CITY PLAN COMMISSION STAFF REPORT

Project Name
East Campus Office & Manufacturing
MPD Plan

Request
CD-CPC-2023-00150 – Rezoning with Plan

Plan Conditions

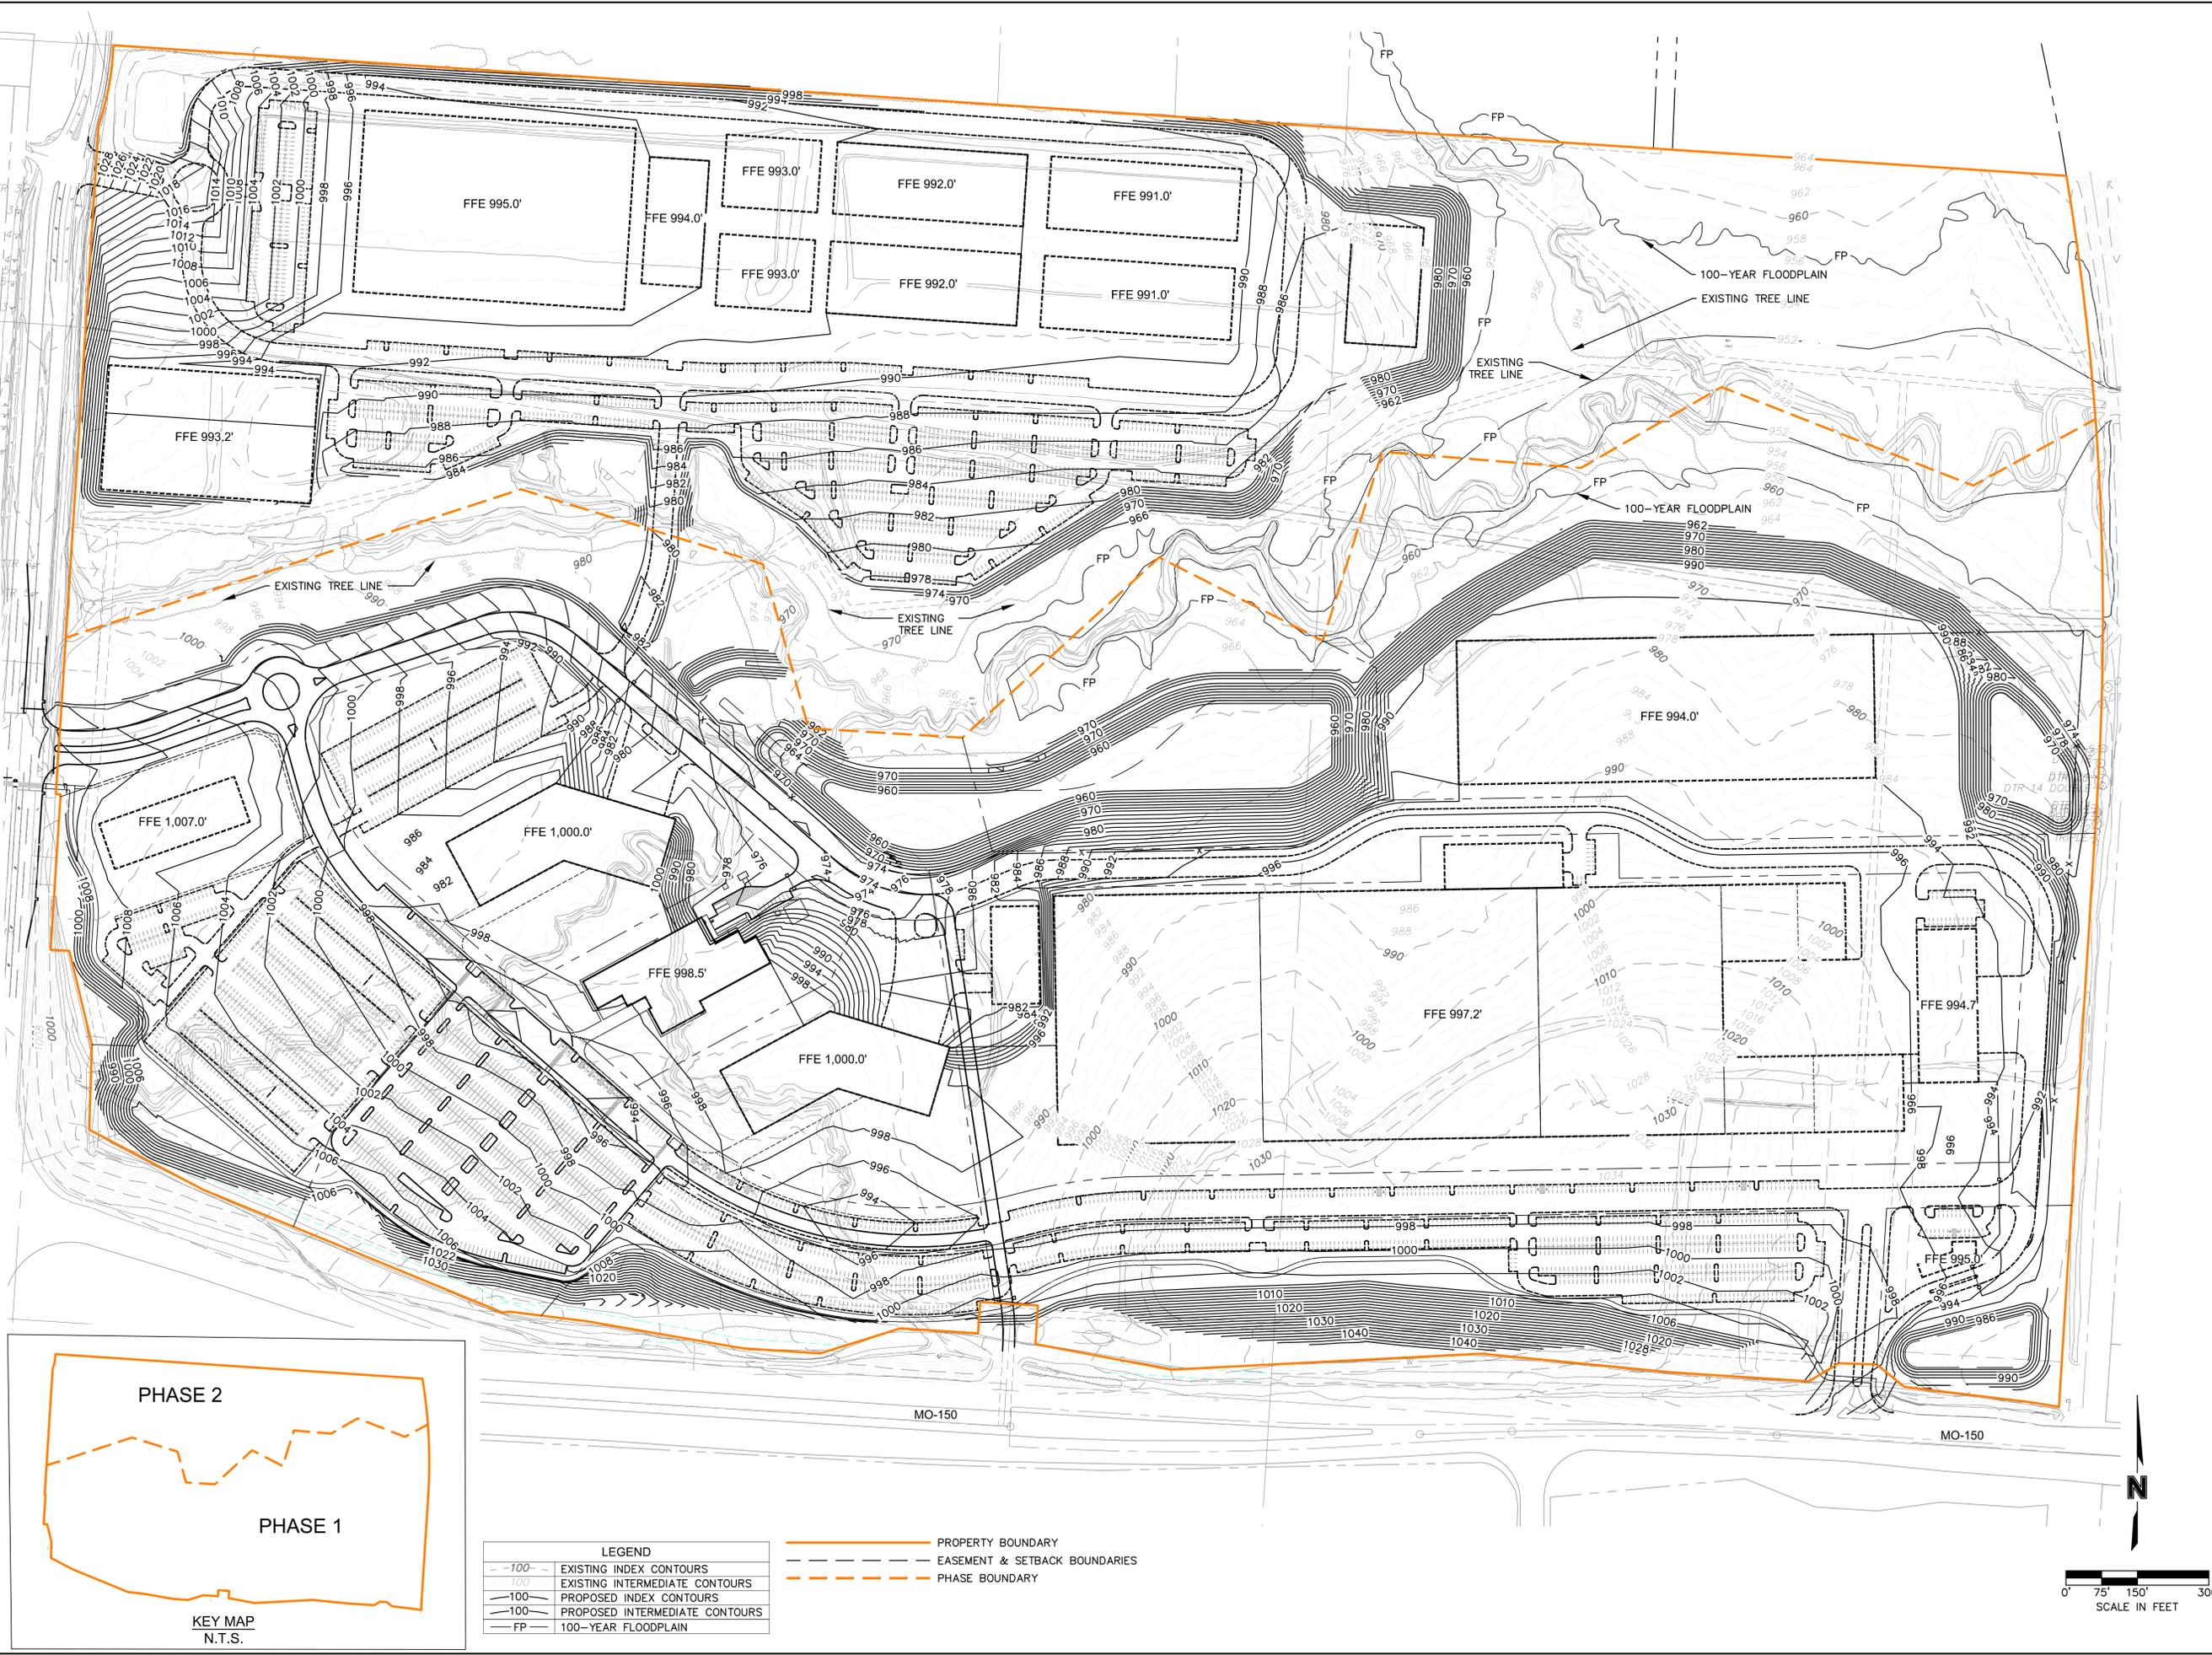
28. The turning radius for fire department access roads shall be 30 feet inside and 50 feet outside radius. (IFC-2018: § 503.2.4)
29. IFC (2018) § 503.1.1 The building labeled "Future Manufacturing 262,500 SF" shall be submitted for review and approval as part of the MPD Final Plan showing the method of meeting exceptions for fire access roads.

31. IFC (2018) § D104.1 The temporary access road that passes between buildings 203 and 251 shall be constructed on-site regardless of access to MO-150 Highway to provide for emergency vehicle circulation.
